PLANNING DEPARTMENT – Development Review Services

**RE: Albuquerque Biopark Zoo Penguin Exhibit (File: K13D034G)**  
**Grading & Drainage Plan, Engineer's Stamp Date 9-15-2016**  
**Supplemental Information, Engineer's Stamp Date 10-5-2016**

RE: **ALBUQUERQUE BIOPARK ZOO PENGUIN EXHIBIT**  
**RESPONSE TO REVIEW COMMENTS DATED September 30, 2016**

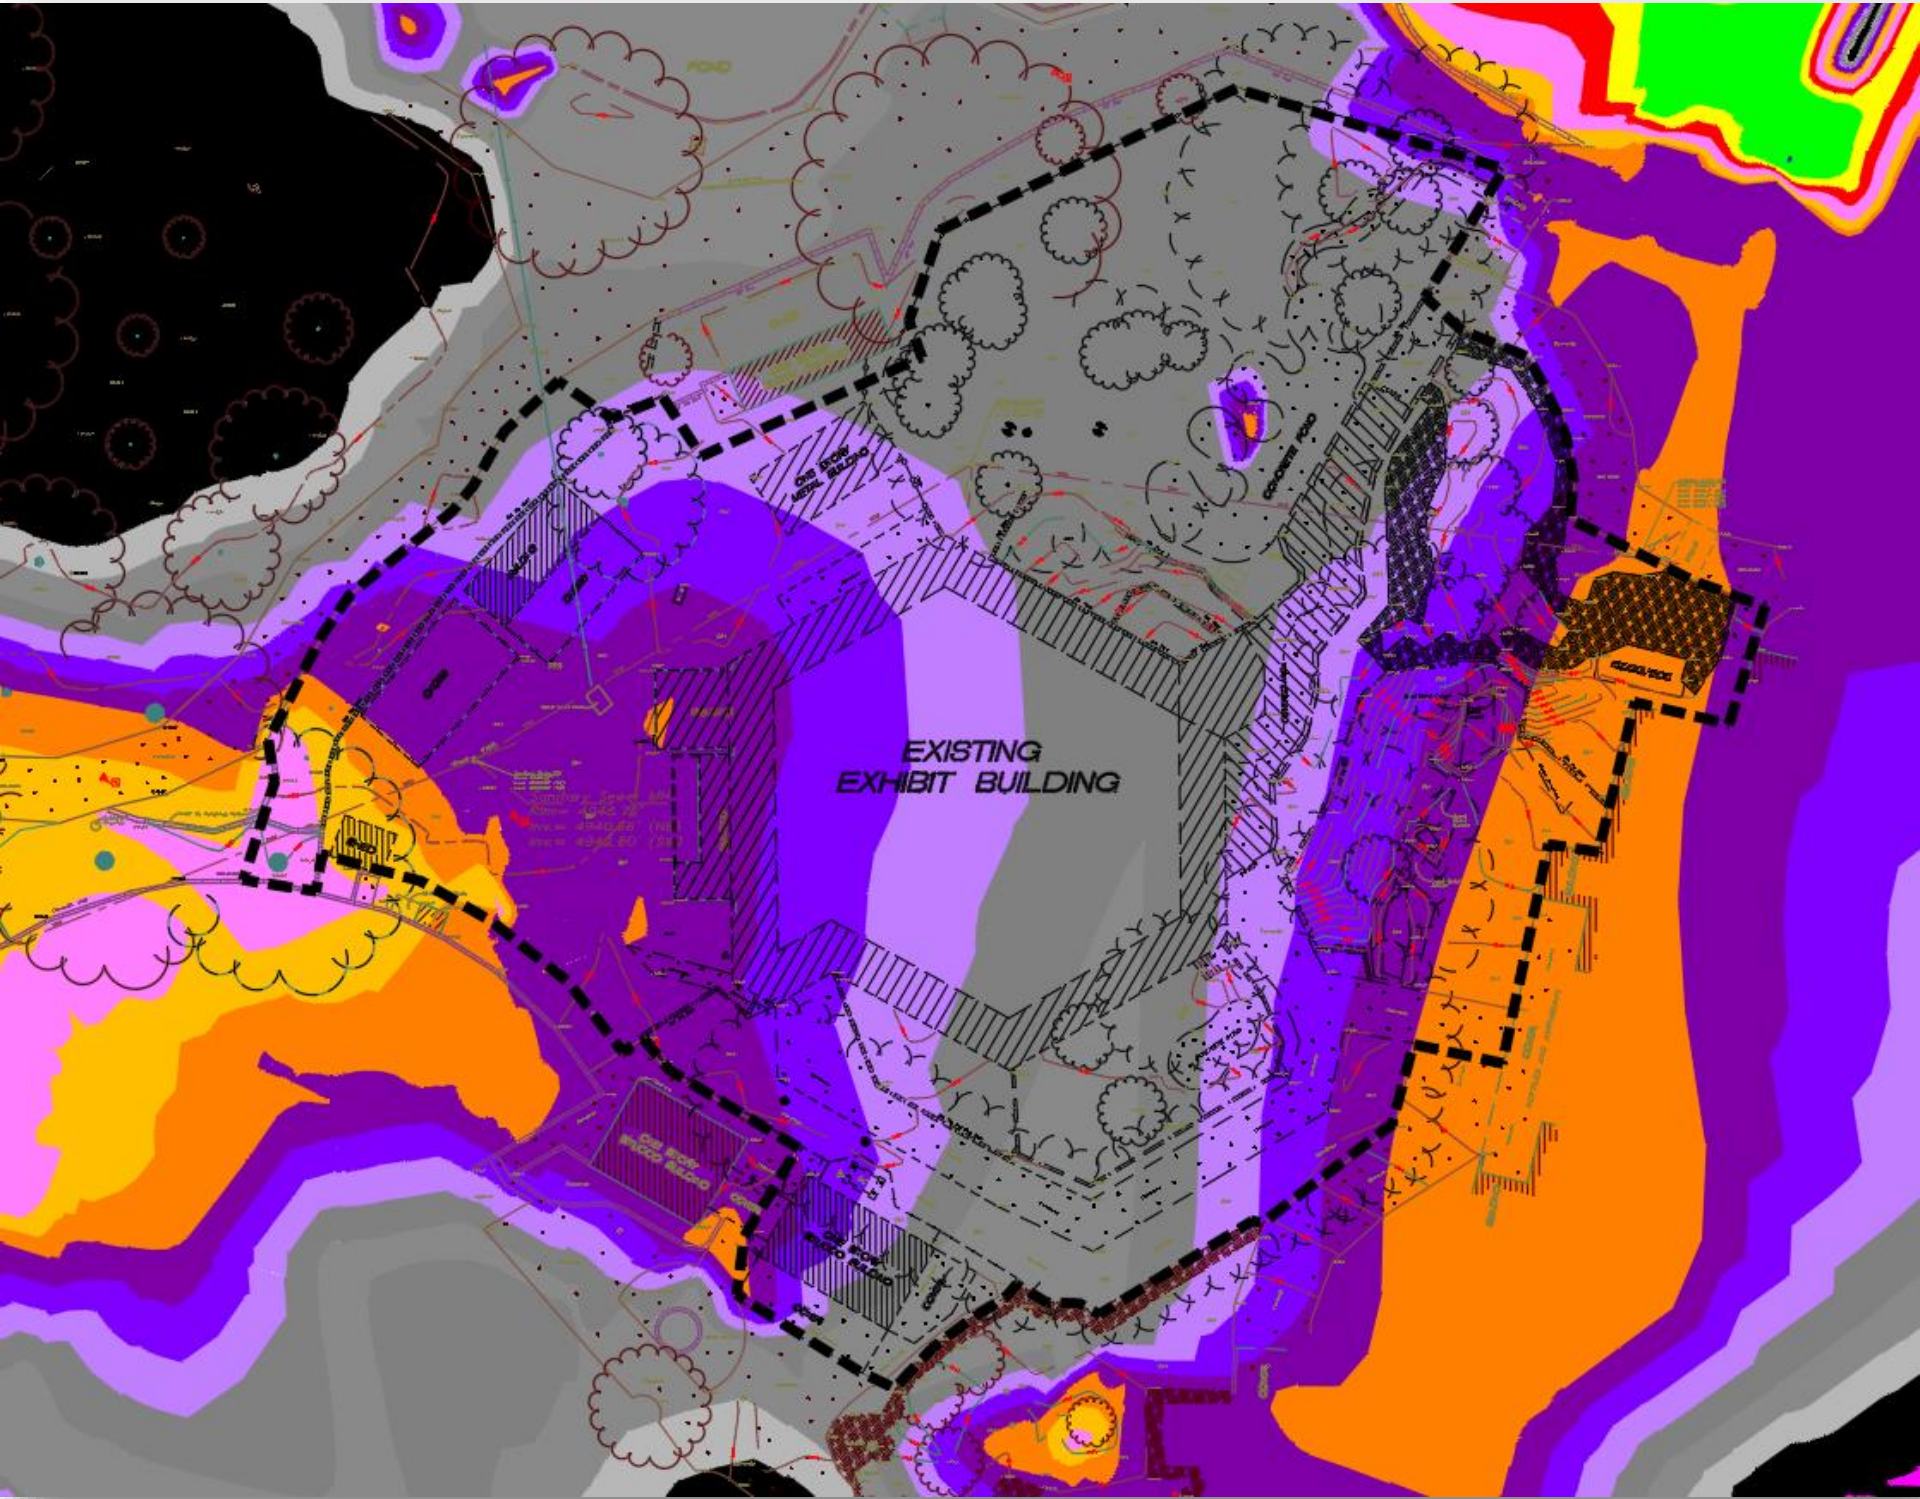
1. Aerial image showing the location of the proposed development within the zoo is provided. We have also included portions of our in-house elevation analysis which was used to set the proposed building grades (using the Bernalillo County contour files). The existing low elevations to the north and south (shown black) are 4947.0 to 4947.5. Any excess stormwater will continue to pass north and south. The grading concept for both existing and proposed conditions utilizes landscaping for water harvesting with overflow to adjacent landscaping and ultimately to the lowest portions of the zoo property. There is no significant difference between pre and post development impervious area which would adversely impact the existing conditions.

Per the colored elevation banding study shown with the existing exhibit building which will be demolished to make room for this project, the orange/pink reflects higher grades to the east and west (4949 to 4951) with the center gray/lavender at 4947.75 to 4948.50 sloping to lower grades to the north (the zoo park area) and south.

Using this information, we established a design grade of 4948.7 as the control elevation for the building.

The lower level grade of 4946.2 is depressed below this control grade but all openings to the building lower than 4948.7 are enclosed.

The center of the park area and the south low area (shown black) represent the low elevation in the area 4947.0 to which accepts any overflow from the project boundary.

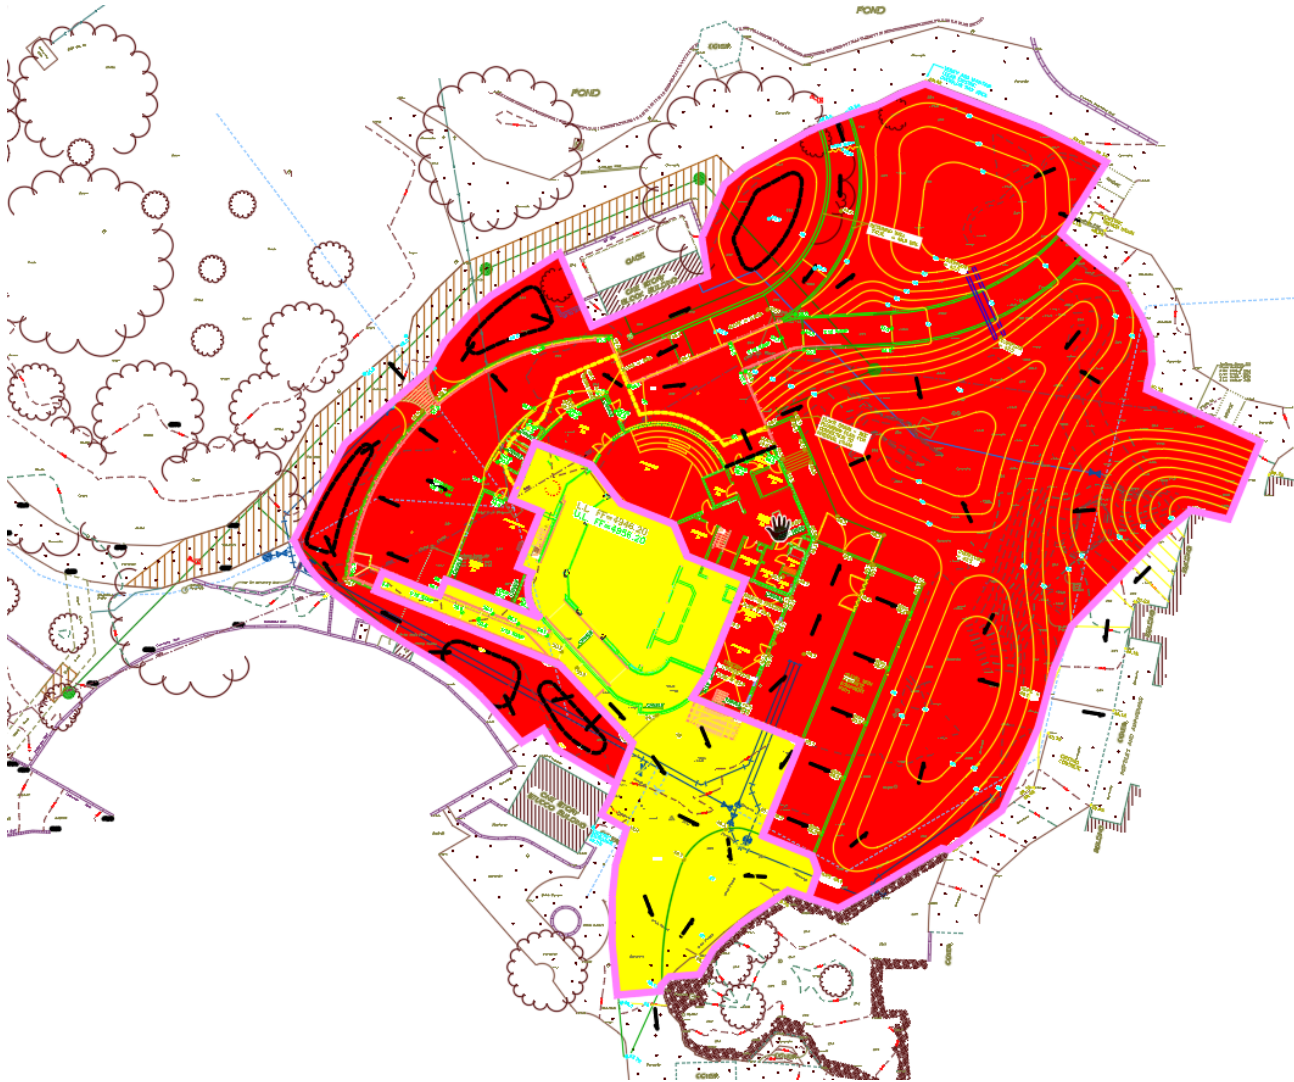
5. A basin exhibit for the project is included.
6. The plumbing plan will be provided as soon as I receive it. This plan calls out the ramp trench drain connection to the SAS system and is currently under review as part of the electronic submittal. In addition, the small floor drain in the concrete landing on the north side (at the bottom of the stairs) will also tie to the SAS system. The reason for this is that the door / landing in this area is below grade and must be sealed to prevent groundwater from rising up into the space. Therefore, the only drain options are sump pump (200 sf with 100-year  $Q=0.02$  cfs) or tie to SAS.

The redeveloped property can be divided into two main drainage basins. Basin 1 (red) which overflows to the north park and Basin 2 (yellow) which overflows to the south.

**SITE PLAN**

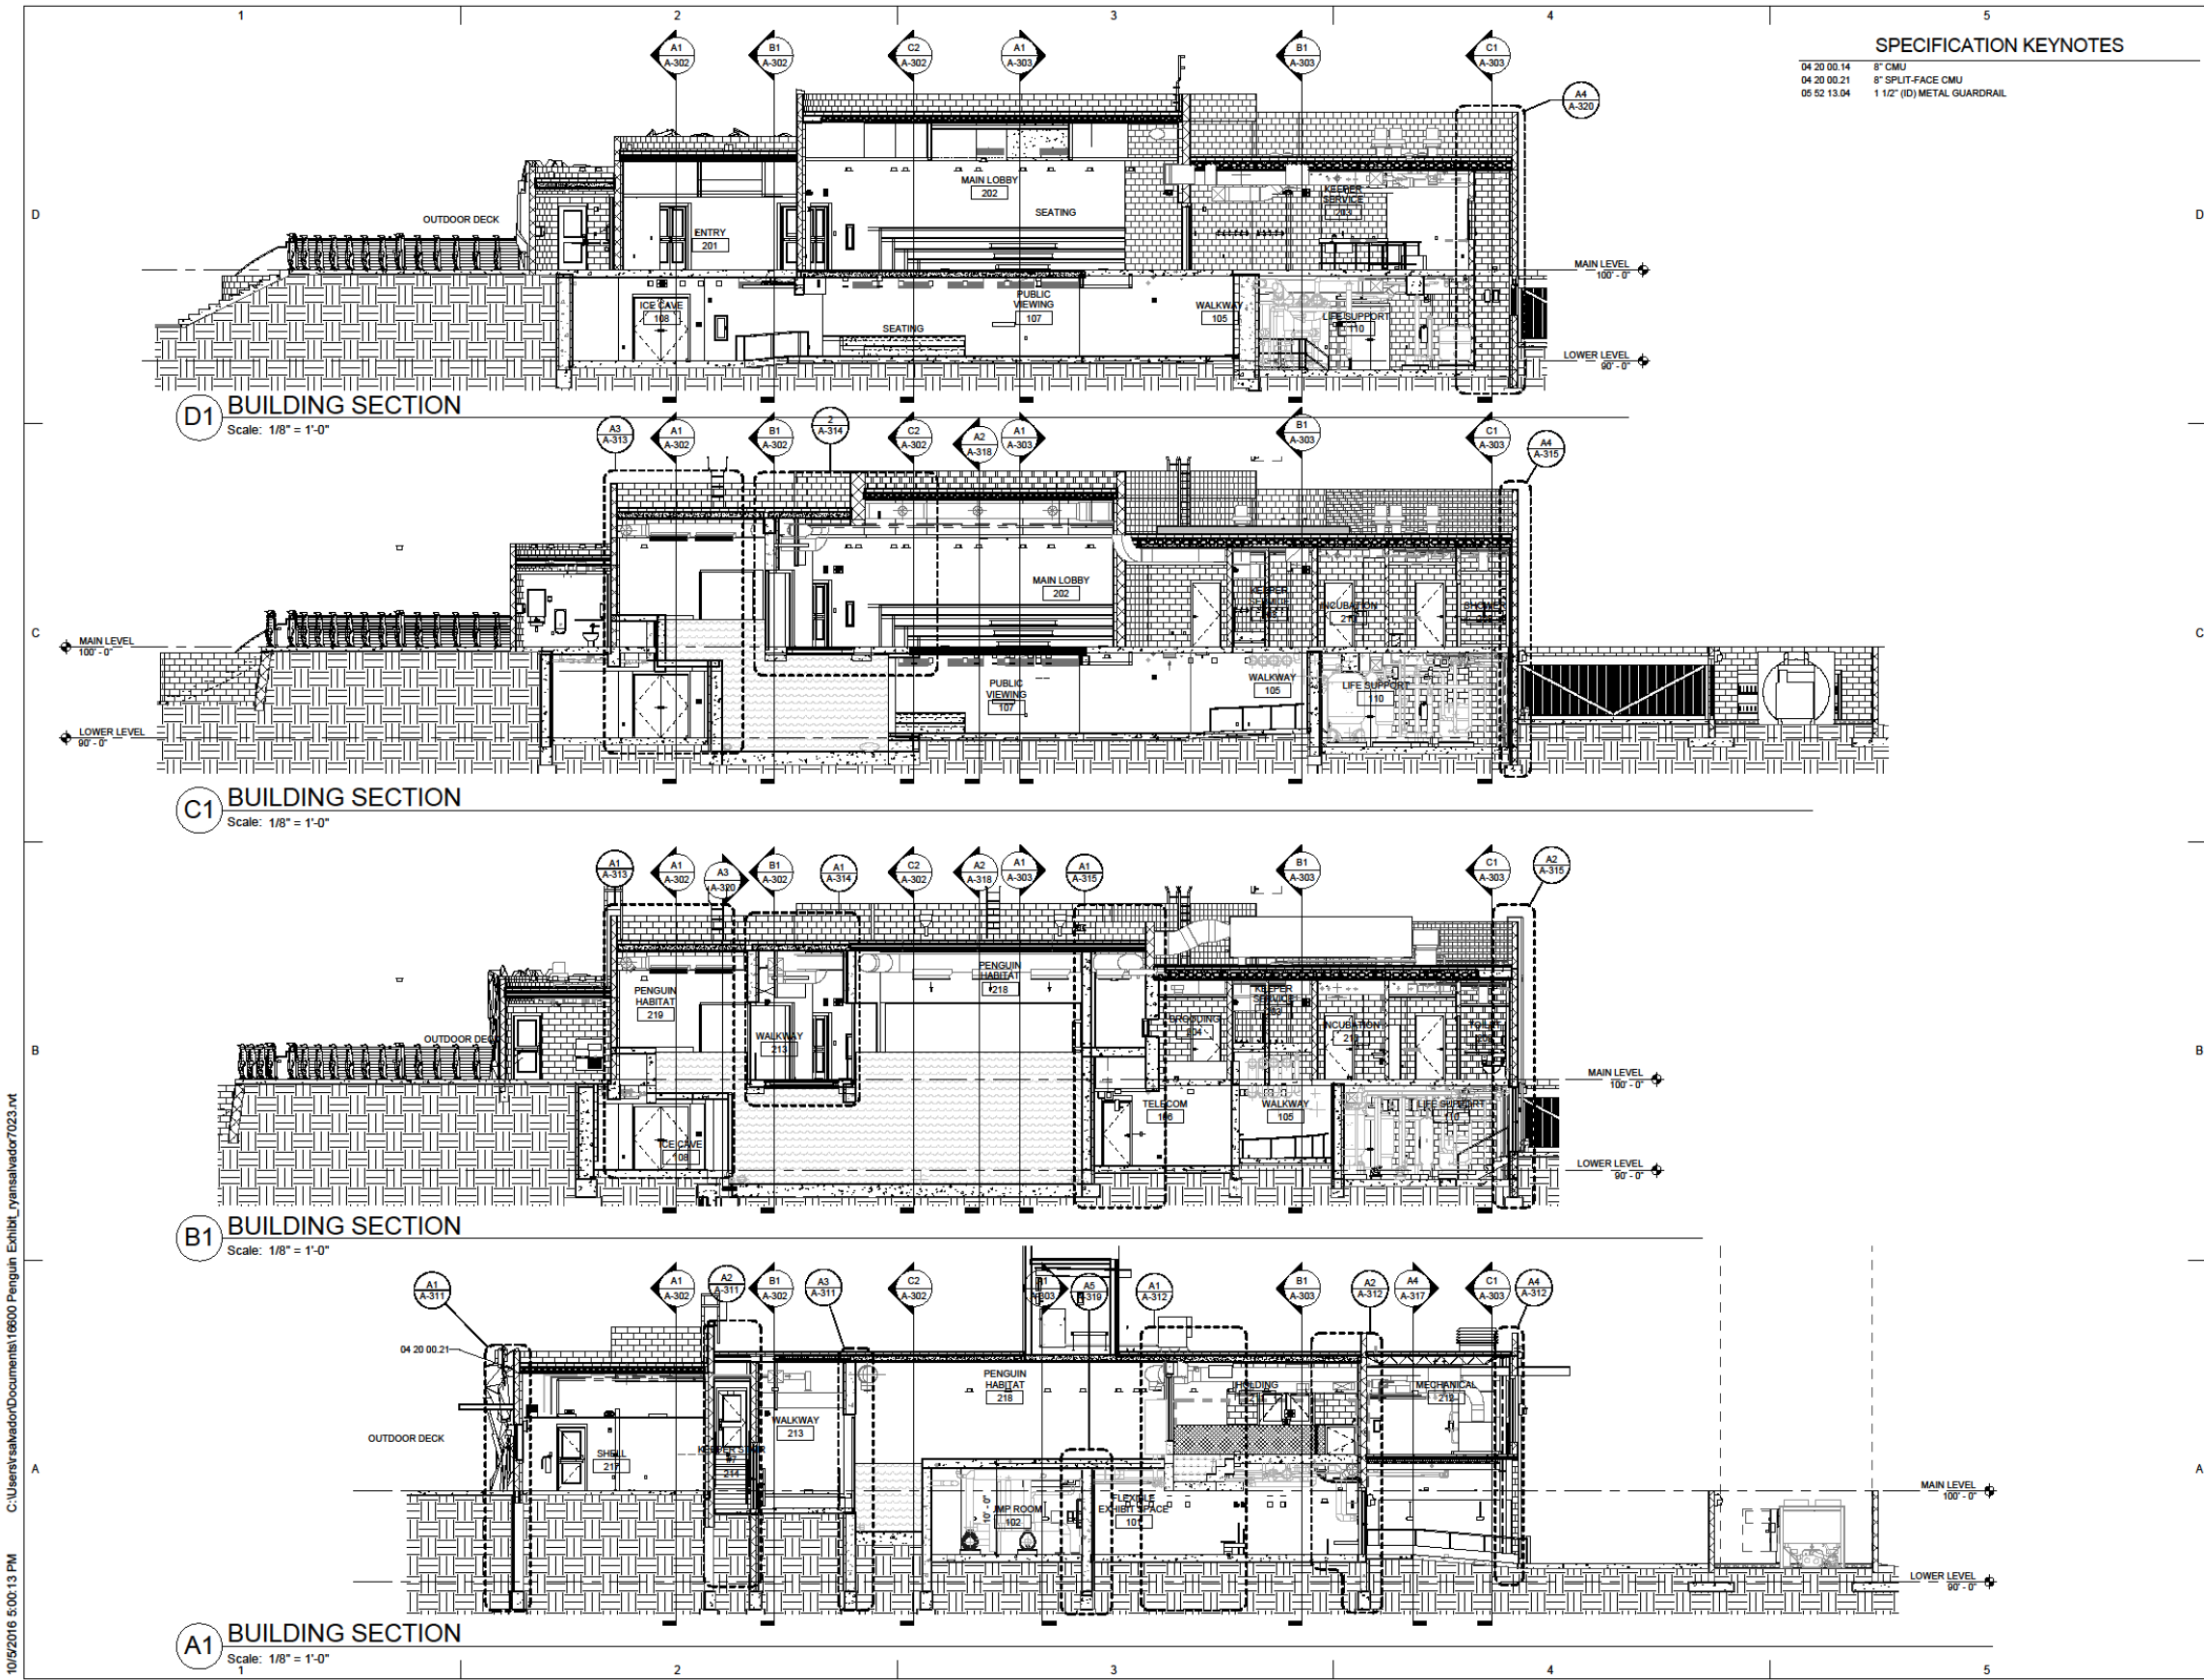
8. A copy of the architectural site plan is provided. This plan clarifies the hard surface areas and the gravel area in the mechanical yard on the east side. Final landscaping is not included in this project. All unpaved areas will be seeded with natural grasses until landscaping is designed / installed under separate contract.

9. Per the architect, the triple lines on the south side indicated standard curb and gutter. The architect has eliminated this C&G from the site base.
10. As noted above, the flat grading design in both the existing and proposed condition consists of localized landscaped areas (water harvesting) which overflowed to adjacent landscaped areas and ultimately overflowed to the historic lower areas to the north and south. The depressions shown on our plan noted as temporary stormwater retention ponds have been relabeled water harvesting / sediment control basins (varying depths from 0.5' to 2.5') with a general note on CG-100 "The proposed development will utilize water harvesting landscaped areas for infiltration. Excess stormwater will continue to the historic low points within the property. The final landscaping will be designed as part of a separate project."
